SHEET		1		OF		1	
MESA TOPS AT RIDGEGATE		ENTRANCE ROAD ALT A — W/O WALLS					
JOB NO.		15950.12

MESA TOPS AT RIDGEGATE
ENTRANCE ROAD ALT B
WI WALLS

PRELIMINARY ROAD REDESIGN
ALTERNATIVE 1
MESA TOPS – CABELA DRIVE
1595018
10/28/2024
SHEET 1 OF 2

MESA TOPS AT RIDGEGATE	ENTRANCE ROAD ALT C	W/O WALLS
SHEET 1 OF 1	JOB NO. 15950.12

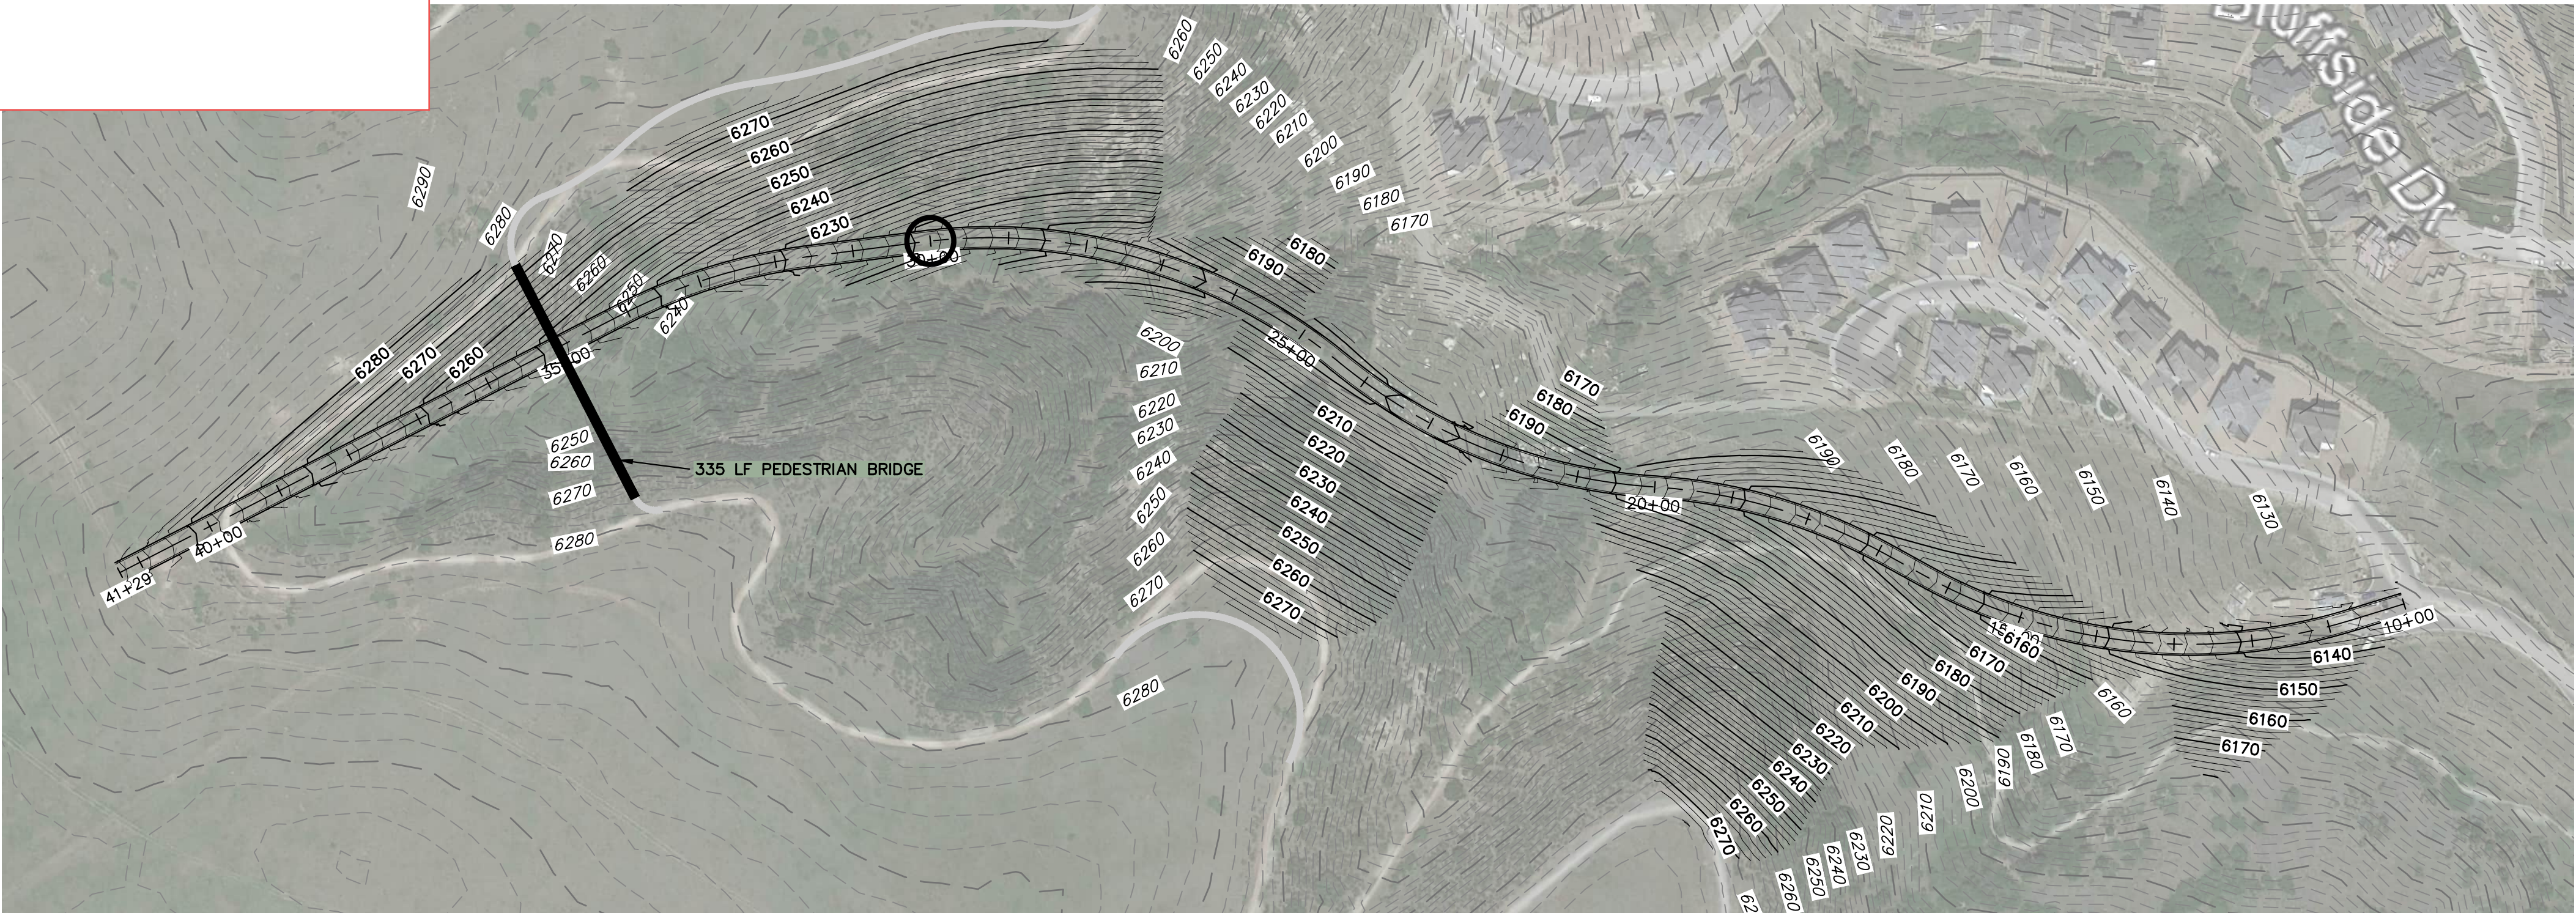
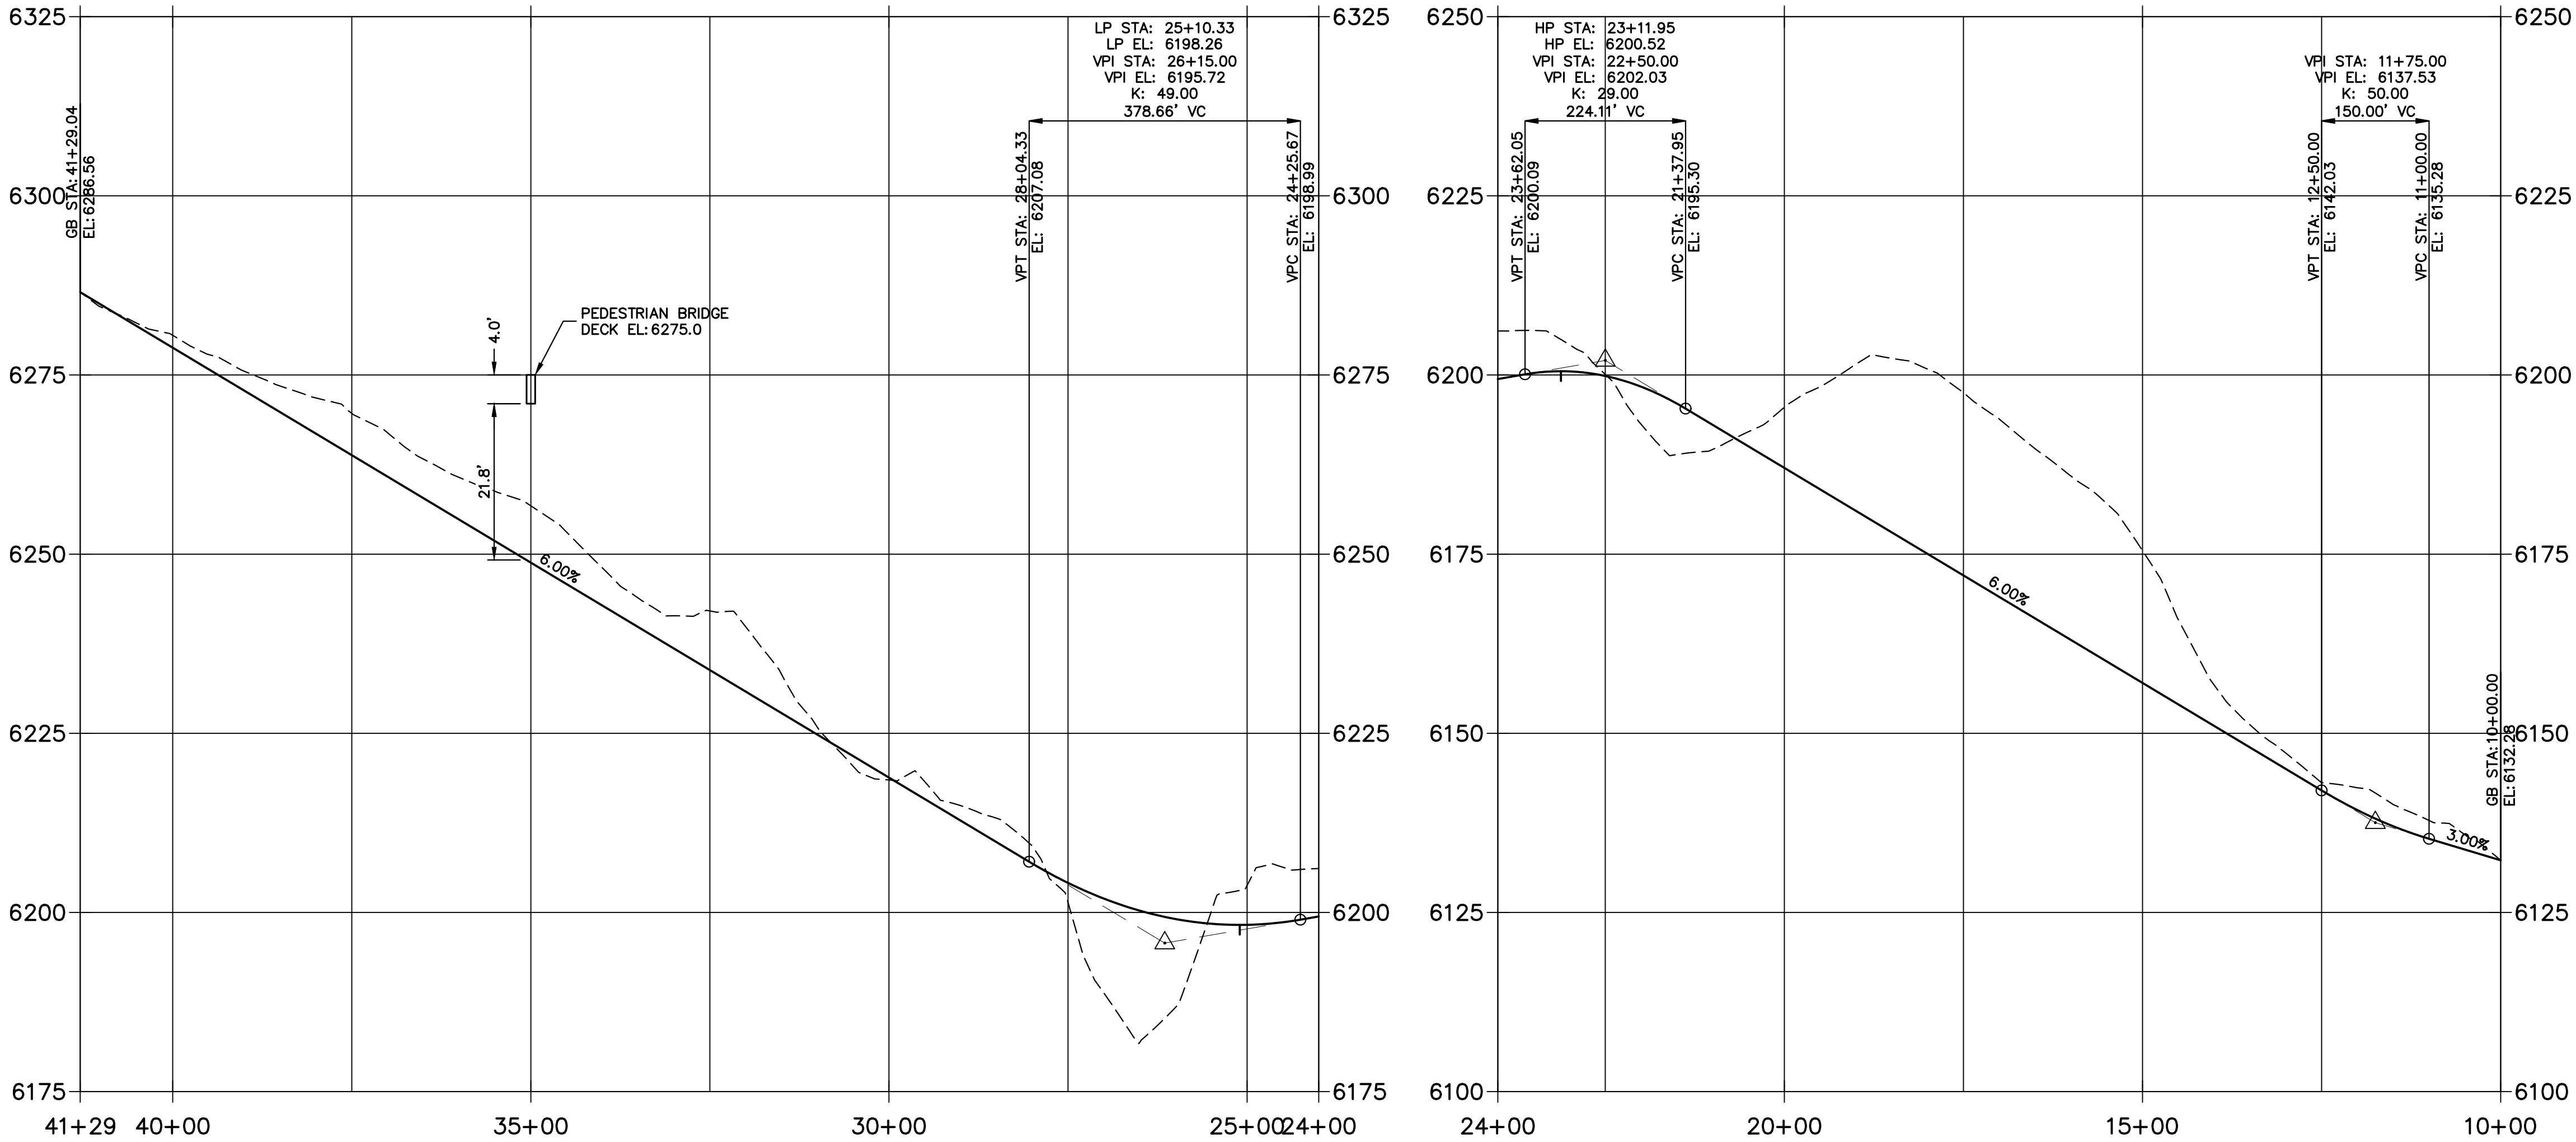
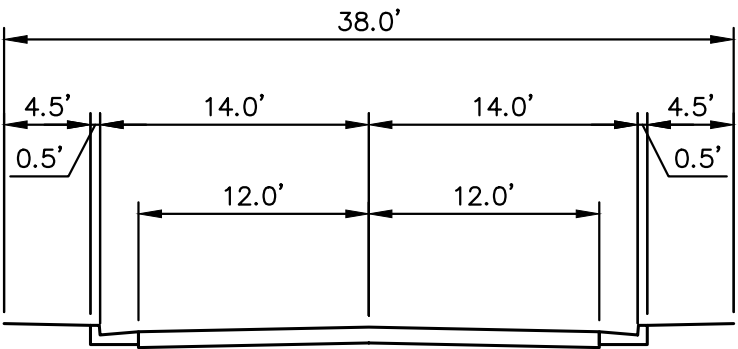
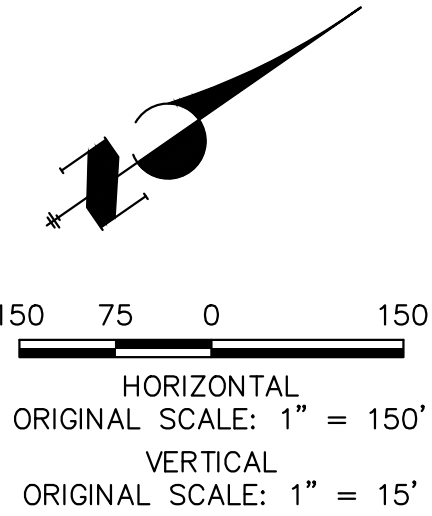
- Option not selected -
- Grading extents too intrusive with no walls.
 - Typical section does not include sidewalk.
